BROWNING MARK IV TRANSMITTER

SERVICE HINTS

BROWNING MARK IV TRANSMITTER SERVICE HINTS (CONT'D)

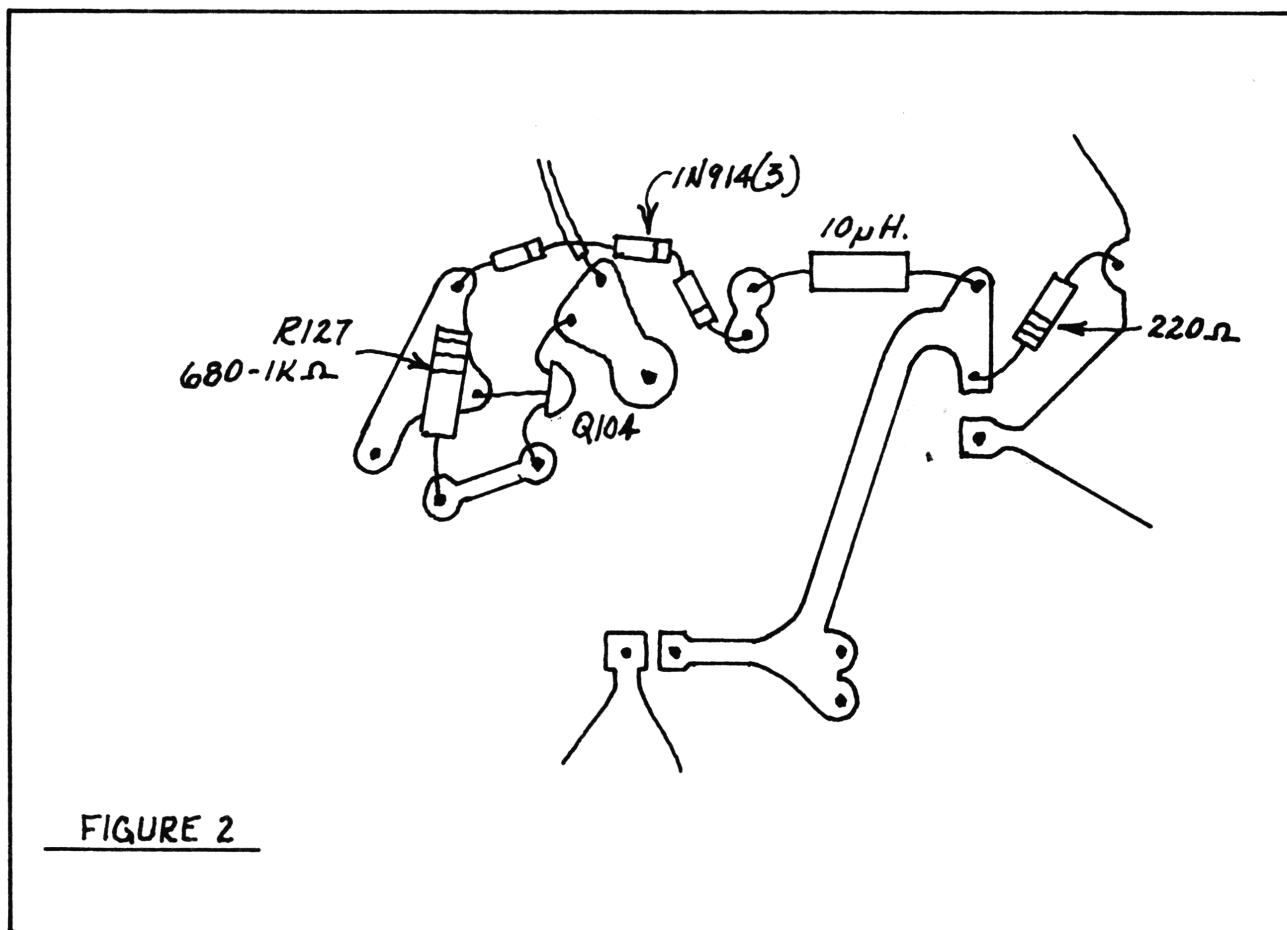
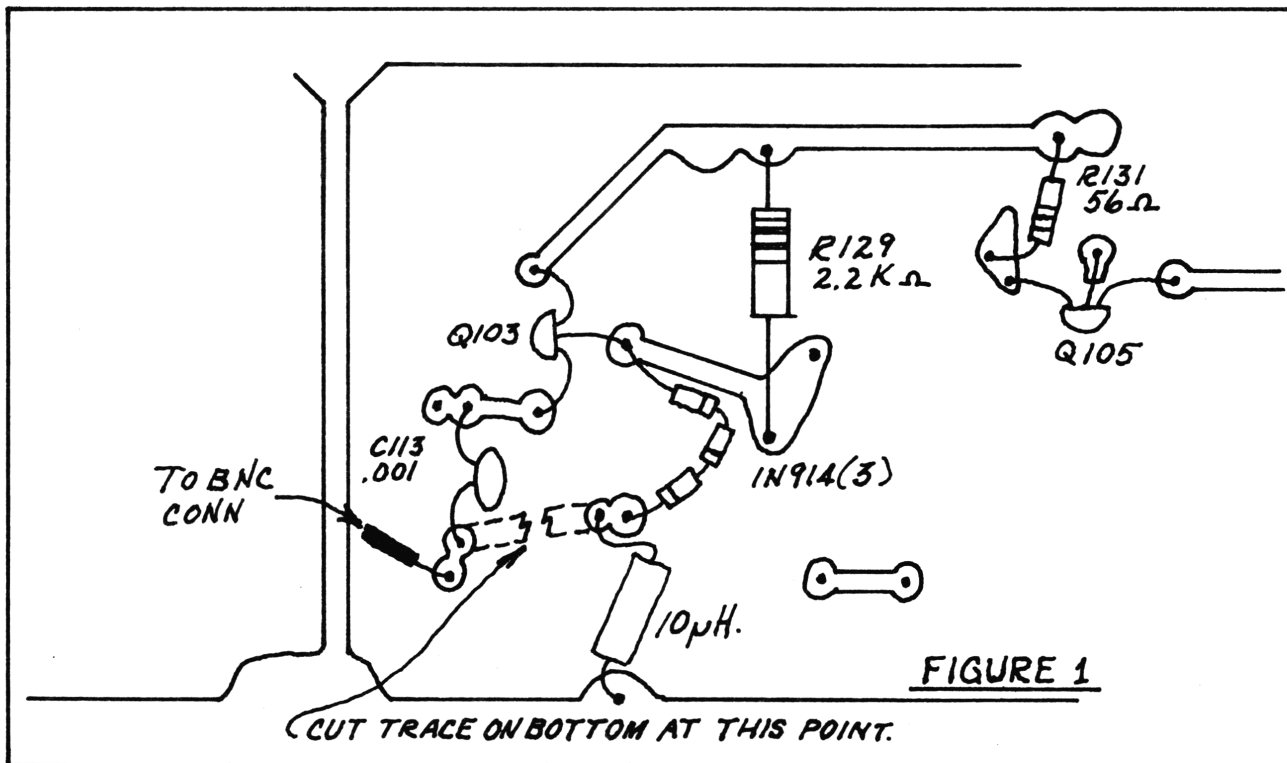
2. The changes noted in paragraph 1 have been incorporated in 40 channel units. All units should be checked to insure that the following changes are included. (Refer to Figures 1 and 2)

- a. 3 1N914 diodes and a 10uH choke (or 2 18uH chokes in parallel) in series from the base of Q103 to ground.
 - b. R129 should be 2.2K
 - c. 3 1N914 diodes, a 10uH choke (or 2 18uH chokes in parallel) and a 220 ohm resistor in series from the base of Q104 to ground.

- d. R127 should be 680 to 1000 ohms (normally 1K)
 - e. R131 should be 47 ohms. If a 100 ohm resistor exists, it is acceptable to add another 100 ohm resistor in parallel on the bottom side of the circuit board.

The RF voltage on the emitter of Q104 should be between 2-3 volts P.P. (preferably closer to 3V.) If this measurement indicates a reading of less than 2 volts check the modifications again to insure that all changes are correct or that the transistors involved are not of the low gain type. Should the reading be above 3 volts select a value of R127 between 680 and 1000 ohms to obtain the desired reading. If the reading is above 3 volts when a 680 ohm resistor is used, add a 10pF NPO from the base to the collector of Q103.

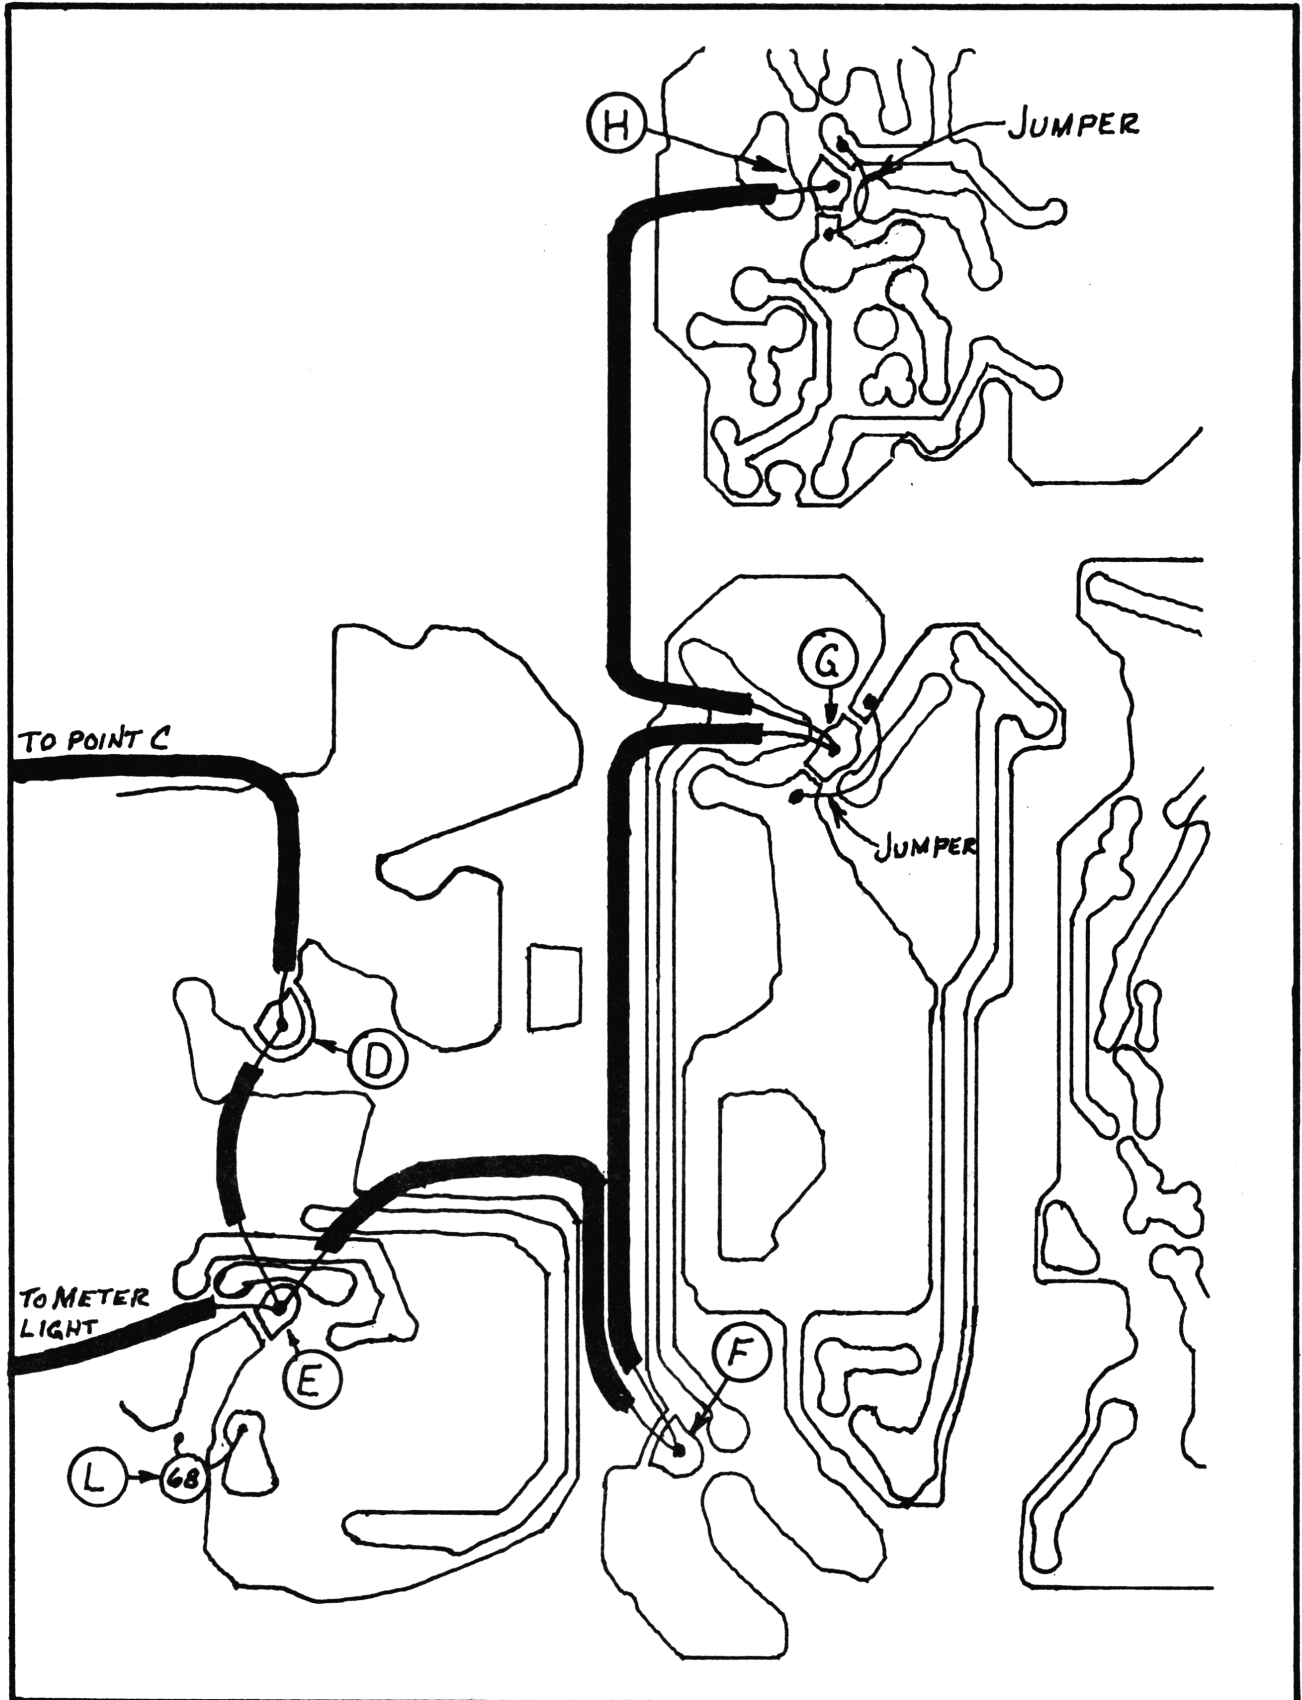
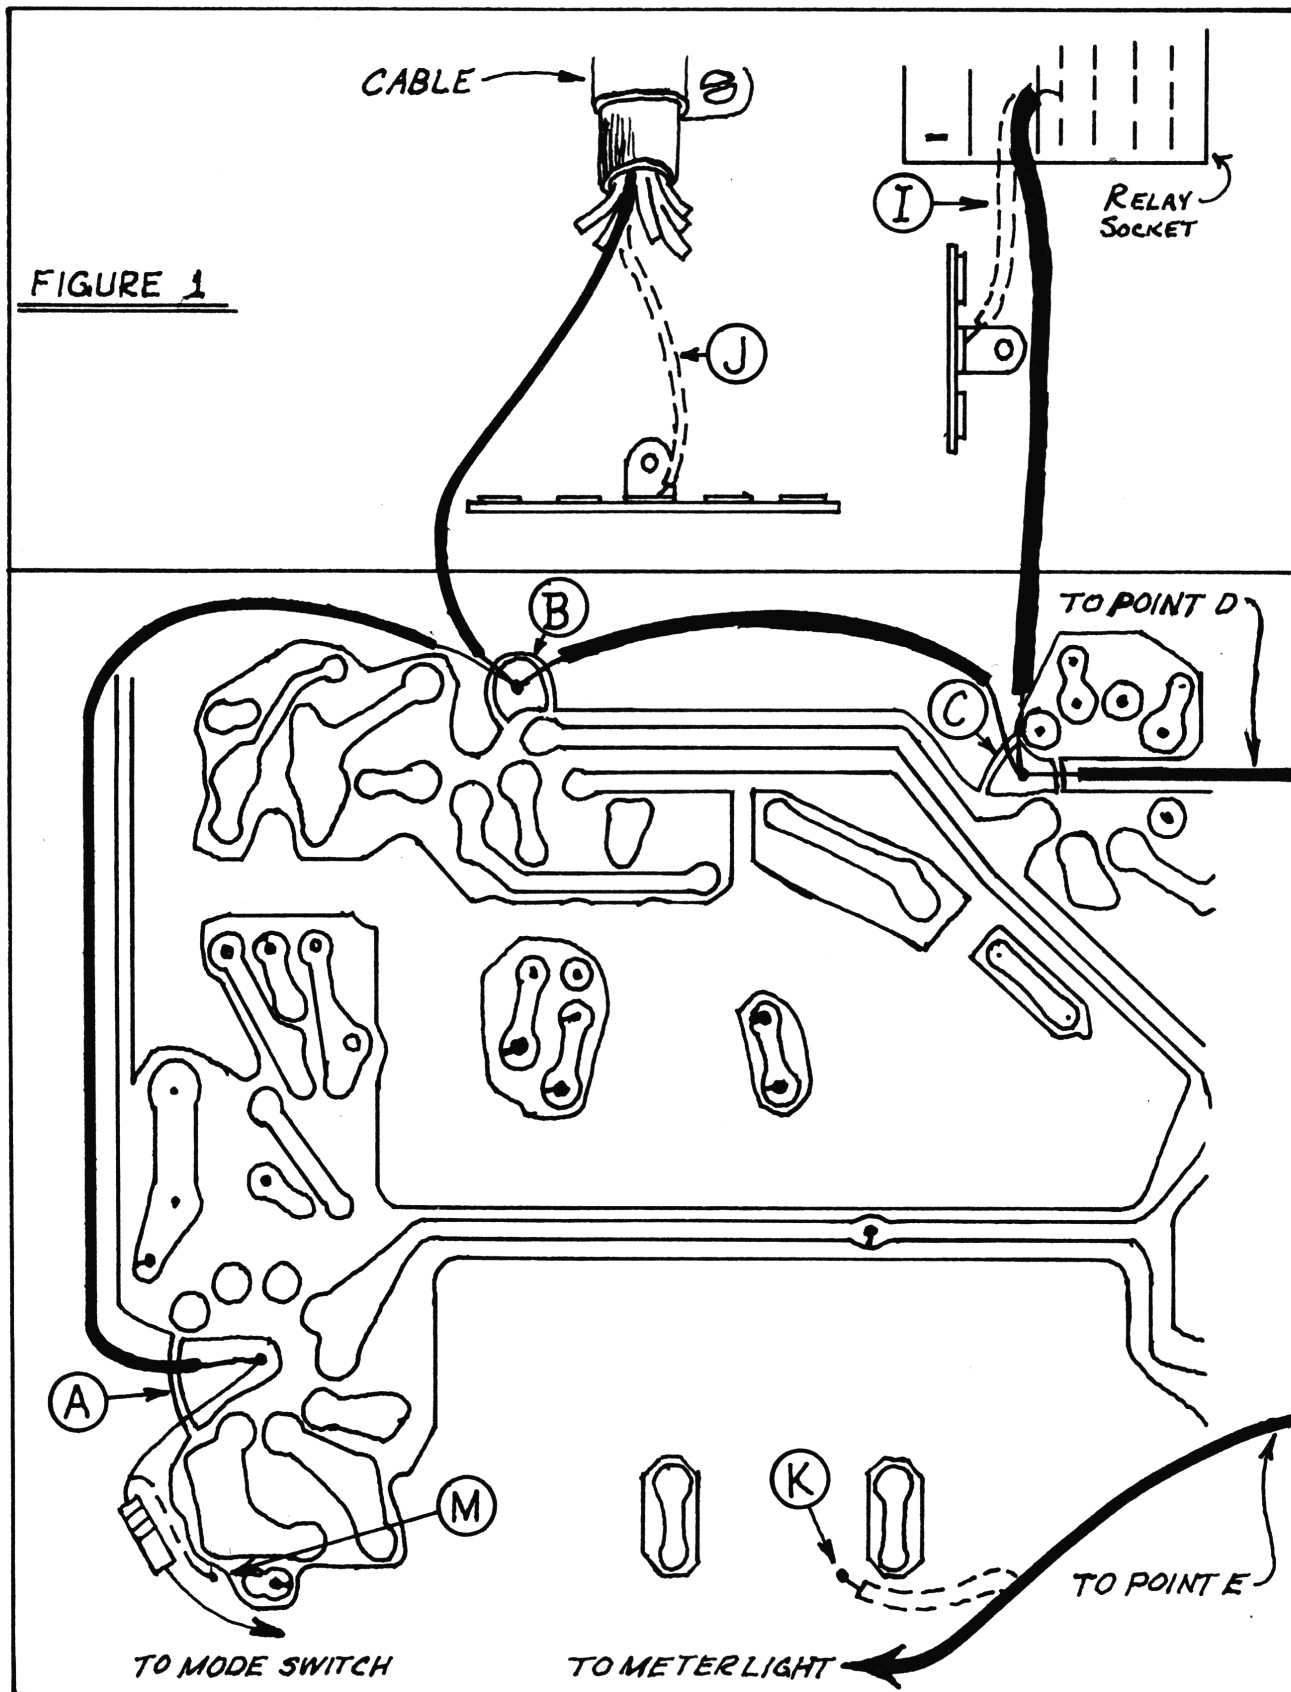
SYMPTOM: Garbled transmit on SSB - especially the upper channels, making it difficult or impossible to clarify it. It has also been described as sounding as if under water.

SOLUTION: Refer to attached diagram.

1. Carefully cut the printed circuit as shown at points A - H - removing the tube filament grounds from the rest of the circuit board ground pattern.

2. Using 18 ga. wire (nothing smaller) connect the filament grounds from points A - H. ROUTE THE WIRES EXACTLY AS SHOWN IN THE DIAGRAM! Any deviation can cause problems such as hum, feedback, etc.

3. Add two small jumper wires at points G and H to connect together the ground pattern on each side of the isolated filament grounds. Keep these jumpers as short as possible without shorting to the tube socket pins.

4. Remove the black wire coming from the meter light socket from where it connects to ground at point K and connect it to the filament ground at point E.

5. Remove C212 (68pF) from its present position on the top side of the circuit board and solder it on the bottom side at point L.
6. Remove the end of the 10 ohm resistor that connects to ground at point M and extending its length with a buss wire and solder it to filament ground at point A.

7. Remove the short wire from the relay socket to terminal strip ground shown by dotted line at point I. Connect a wire as shown from the relay to filament ground at point C.

9. Disconnect the black wire from the control cable, shown by dotted line at point J, where it connects to ground on a terminal strip, and connect it to filament ground at point B. You may have to lengthen it with a piece of 18 ga. or larger wire.
